PROJECT REVIEW COMMITTEE - CITY OF WILDWOOD
PRC Chairperson – Melanie Strickland

Agenda
Regular Meeting
July 14, 2026 10:00 AM
Commission Conference Room 124
100 N Main Street

SUBJECT: **26-0318 SPM - Circle K US 301 & CR 462**

The applicant is seeking approval from the Project Review Committee for modifications to the previously approved plans under the project number SP 2405-001 Circle K US 301 & CR 462. The modifications consist of a natural gas connection, relocation of a transformer, revision to the landscape plan, and changes to the stormwater system based on as-built information, on 3.28 acres MOL.

SHEET NUMBER
C5.1

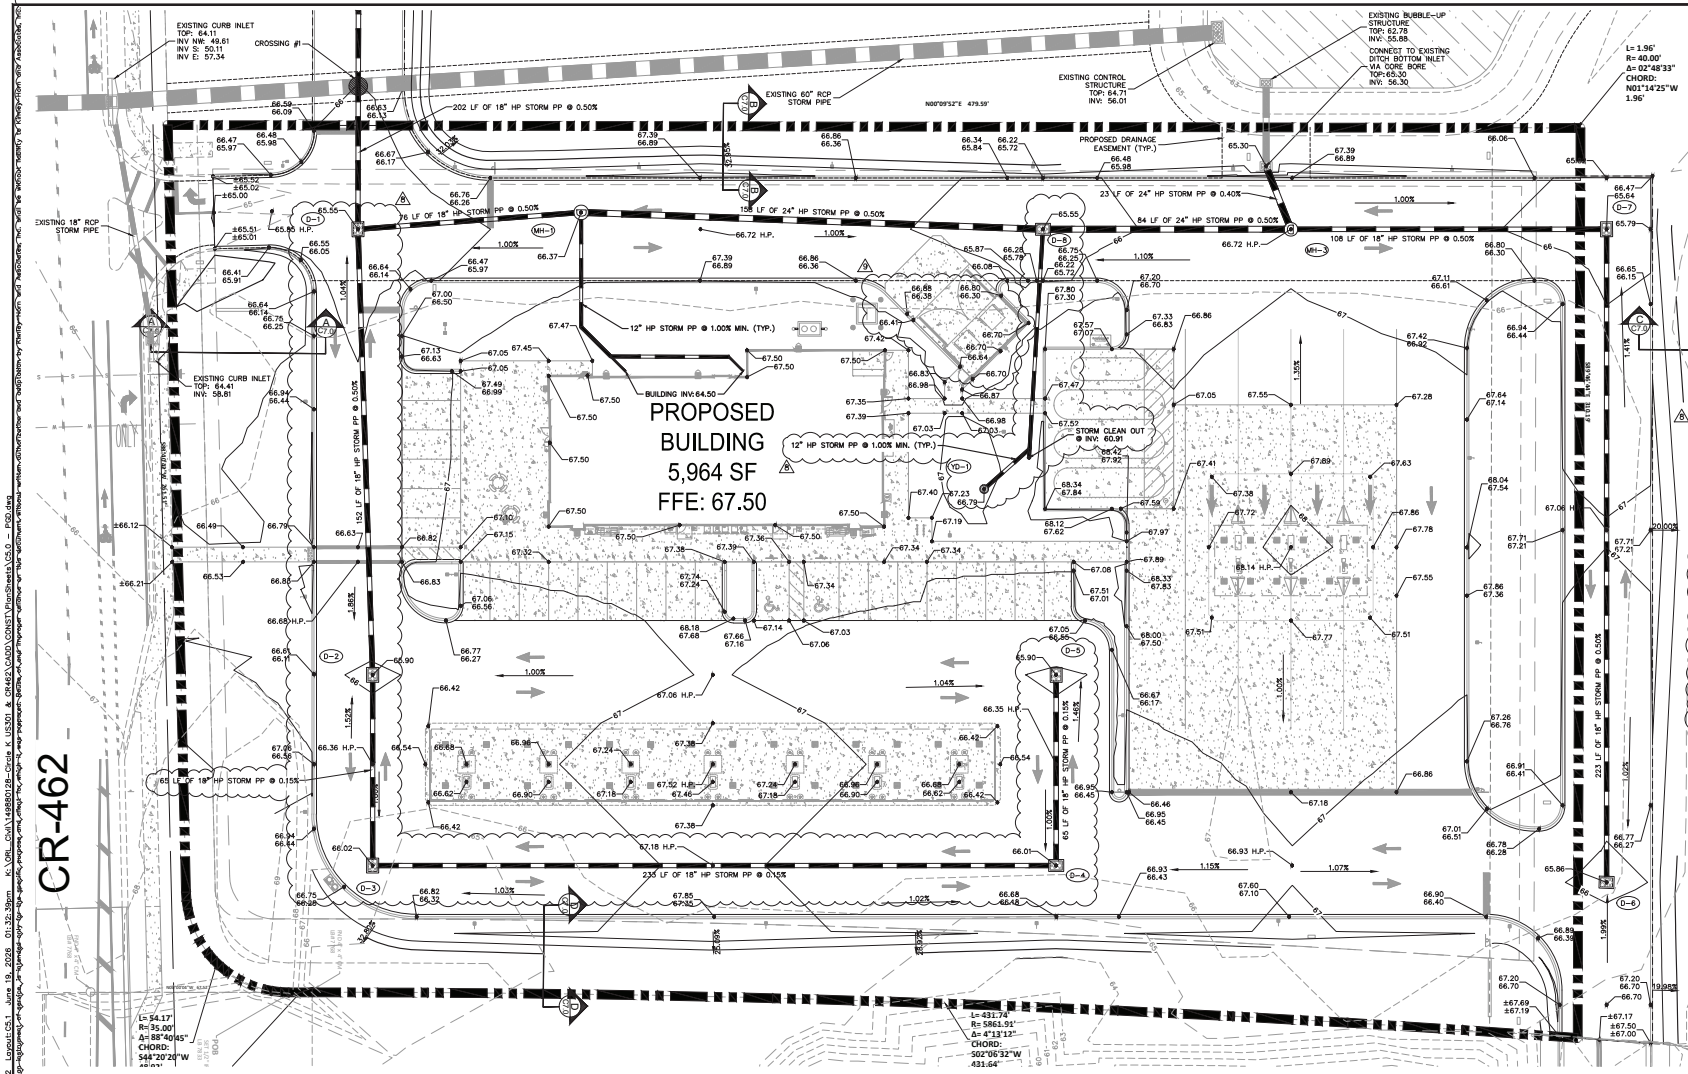
a) Increased storm pipe sizes from 18" to 24" between MH-1 and MH-3 and added spot elevations for the additional heavy-duty concrete per Circle K bid set comments.
b) The proposed grading at the points of connection and stormwater design were revised to accommodate the master infrastructure as-built information.

SHEET NUMBER
C5.2

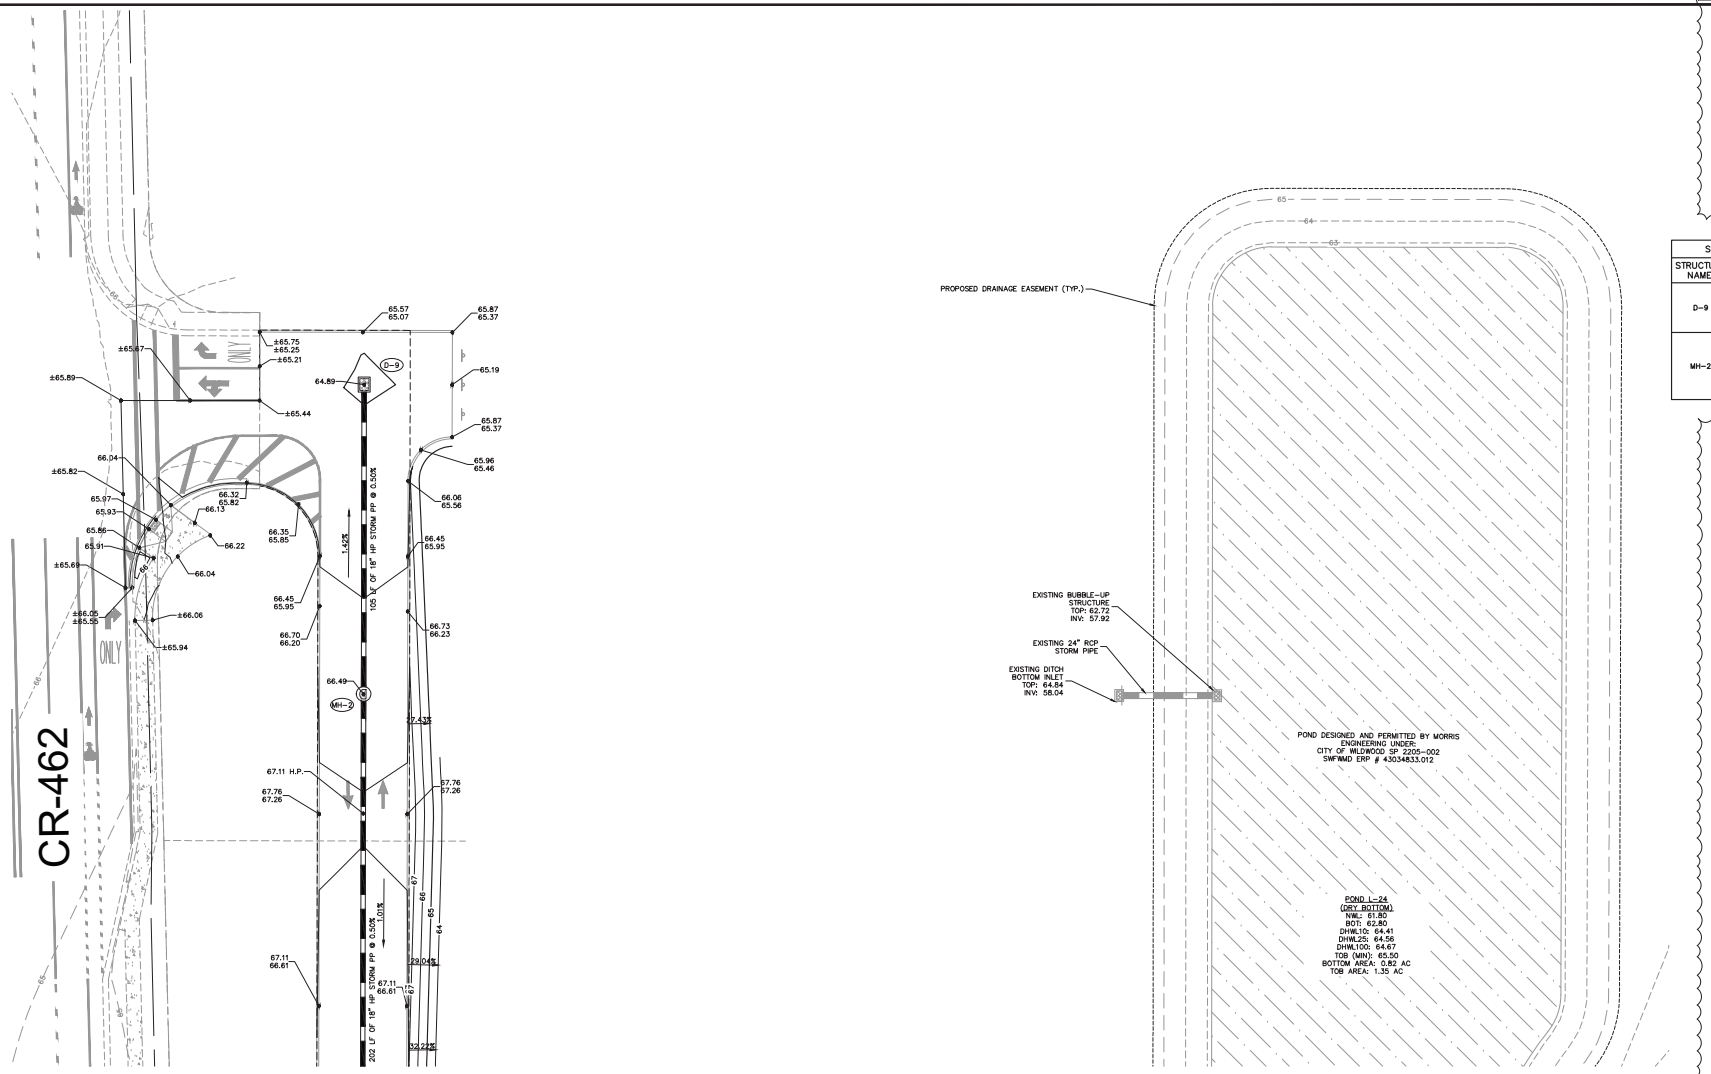
a) The proposed grading at the points of connection and stormwater design were revised to accommodate the master infrastructure as-built information.

SHEET NUMBER C5.3

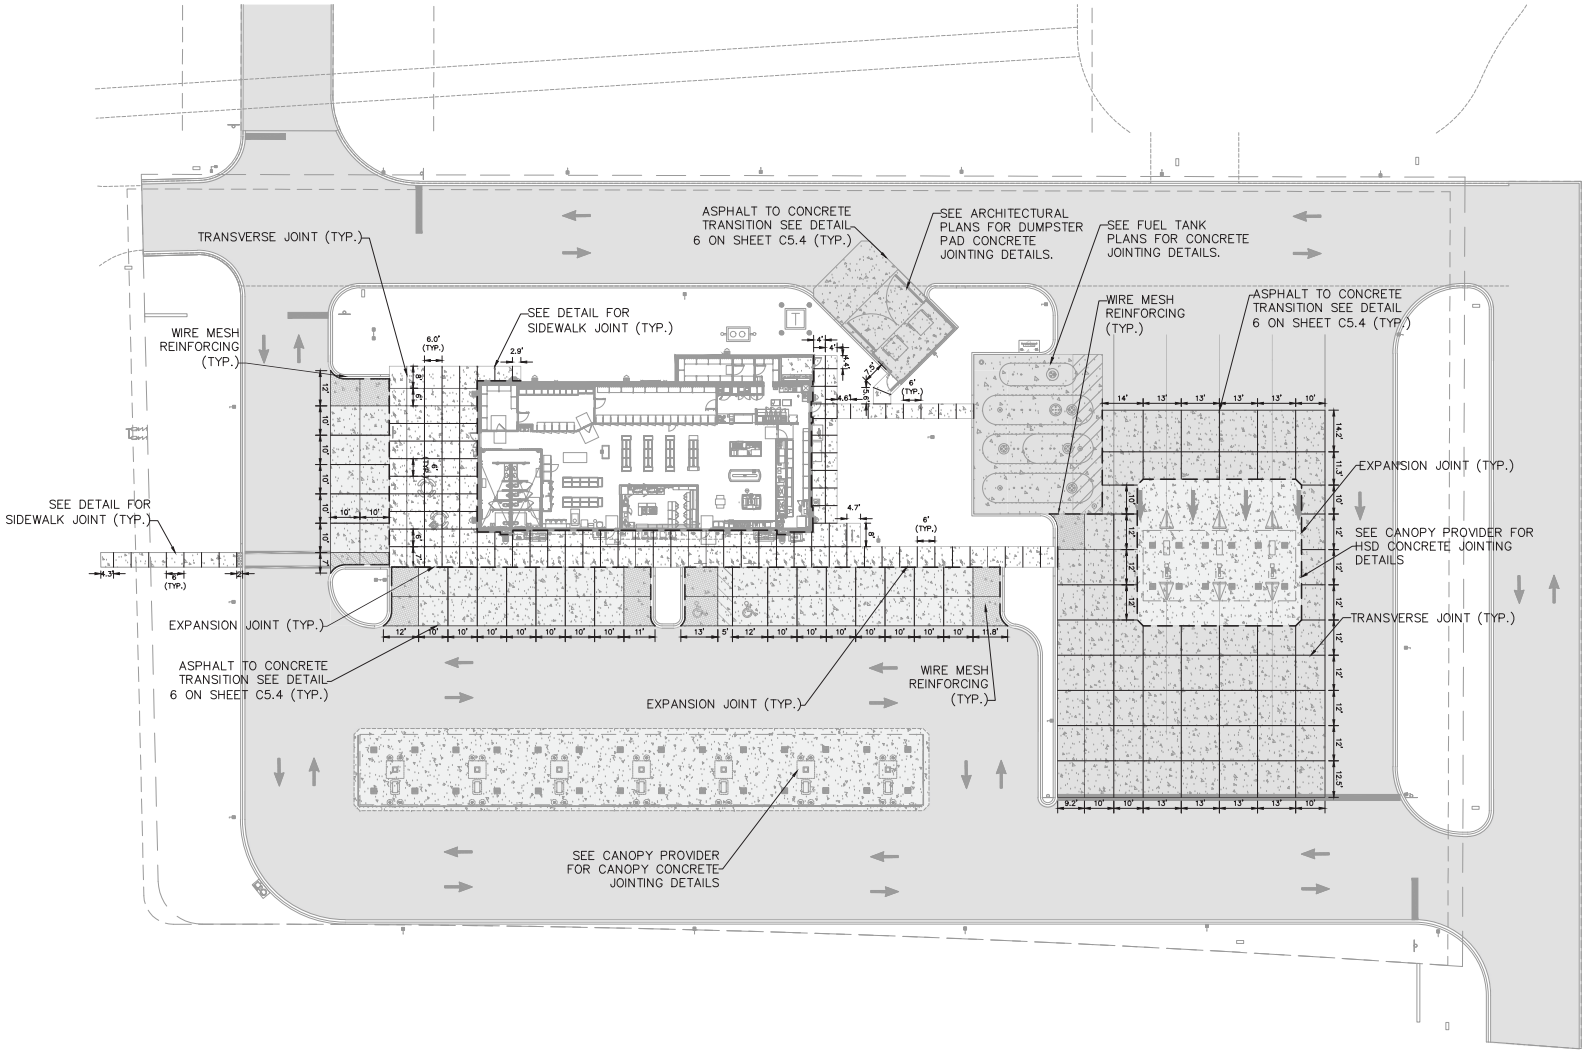
a) Added concrete jointing plan per Circle K bid set comments.

SHEET NUMBER
C6.0

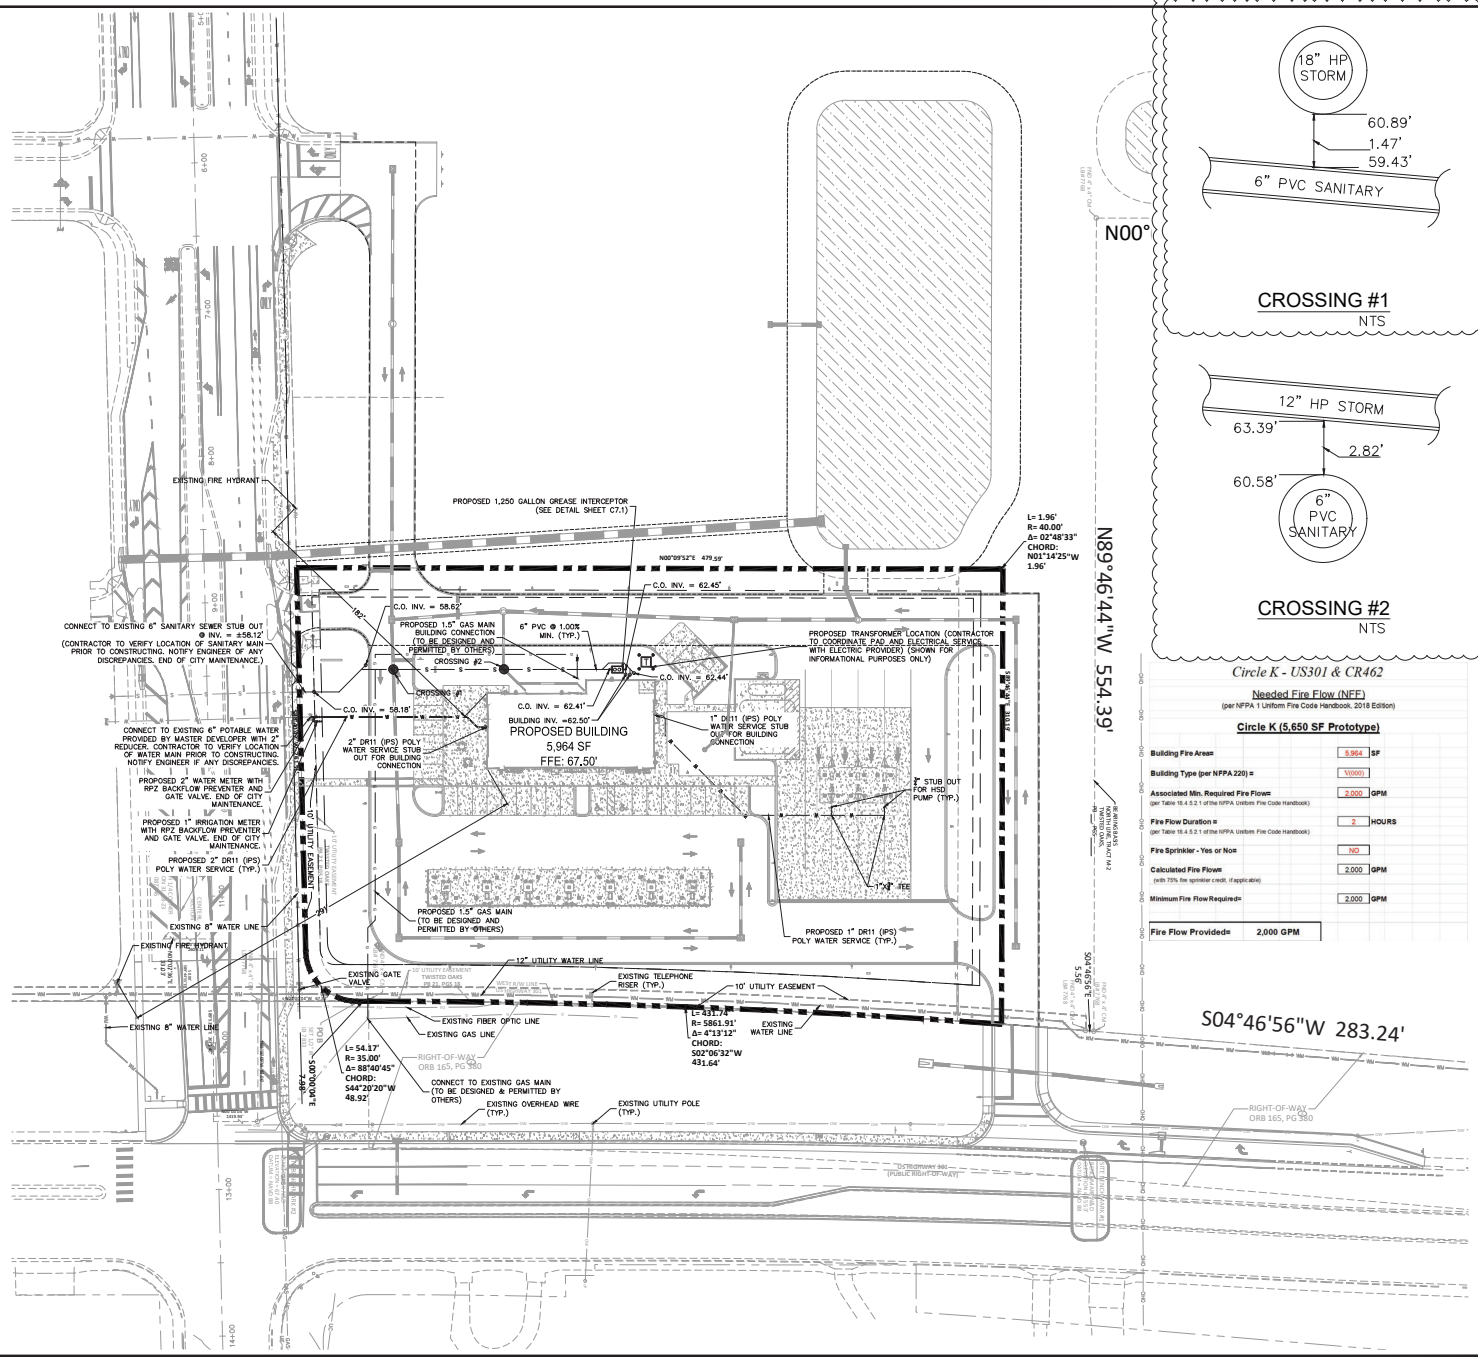
a) Updated to show gas water heater building connection callout and re-routed potable water lines per Circle K bid set comments.
b) The natural gas connection to the building was added per Circle K's request.
c) The proposed transformer was relocated per the electrical provider's request.
d) The pipe crossing details were revised to reflect the updated storm network.

SHEET NUMBER
L1.00

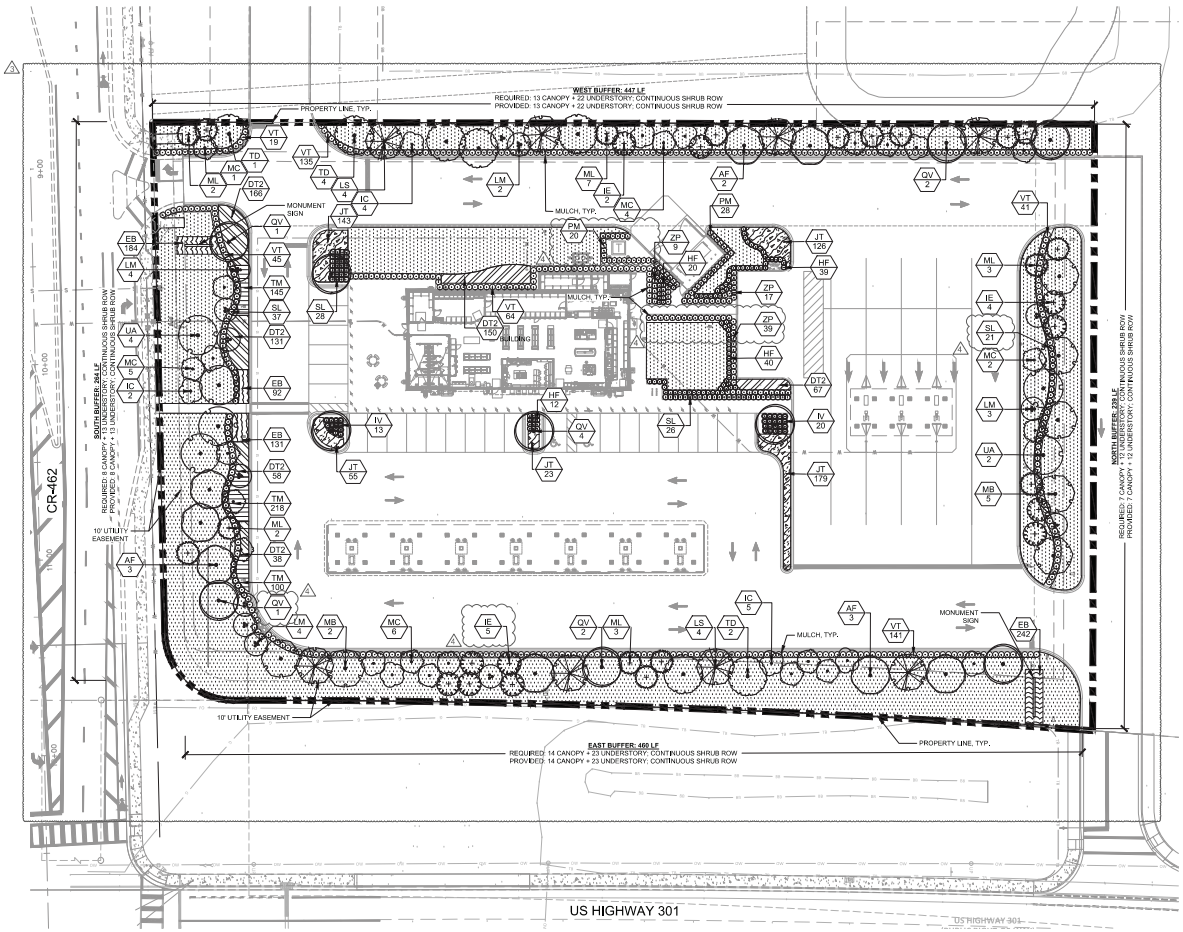
a) Plant labels have been added; added plantings per property line adjustment: 1 live oak, 1 eagleston holly, 5 walter's viburnums.
b) The plantings, plant quantities, and plant labels have been revised to accommodate the updated transformer location.

SHEET NUMBER
L2.00

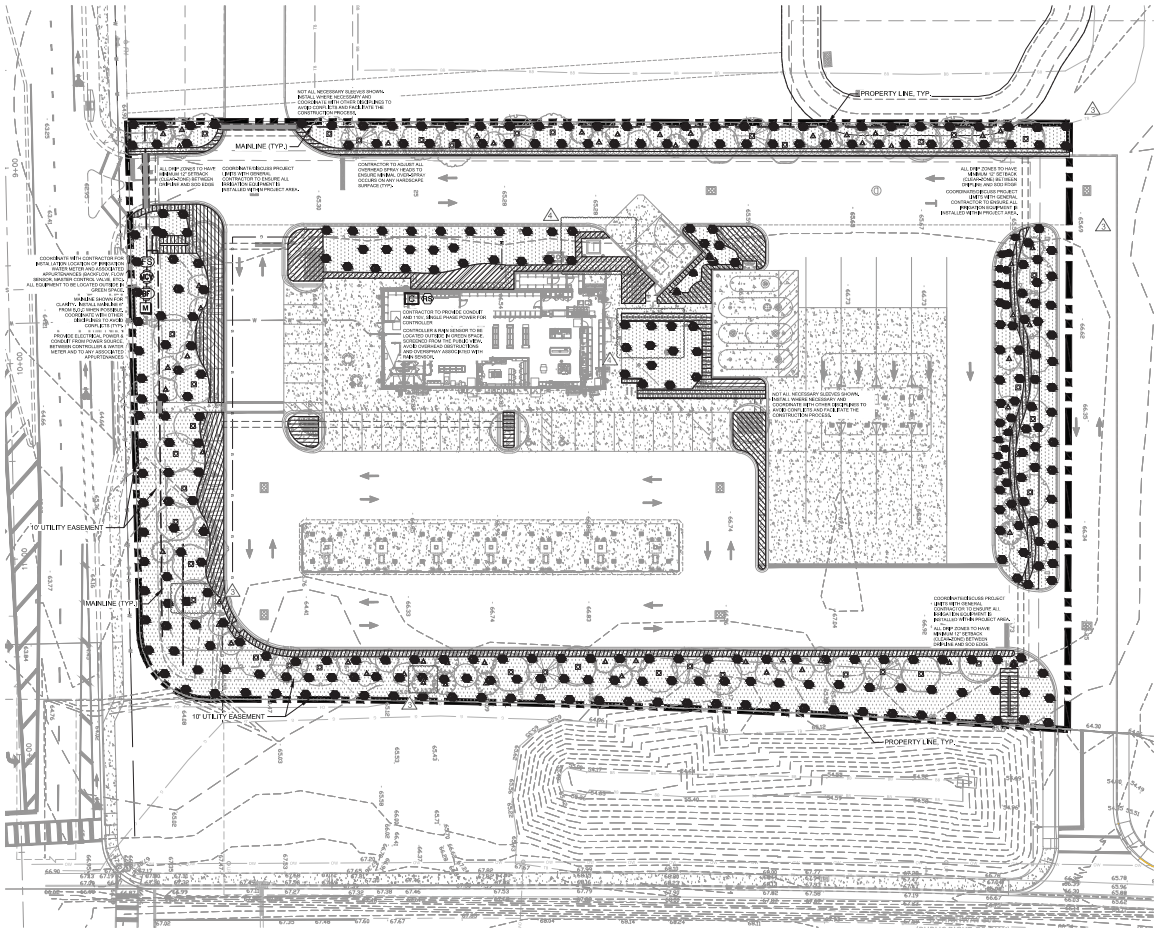
a) Additional irrigation equipment added per planting changes.
b) The irrigation design, irrigation quantities in the irrigation schedule, and irrigation flow totals have been revised to accommodate the updated transformer location.
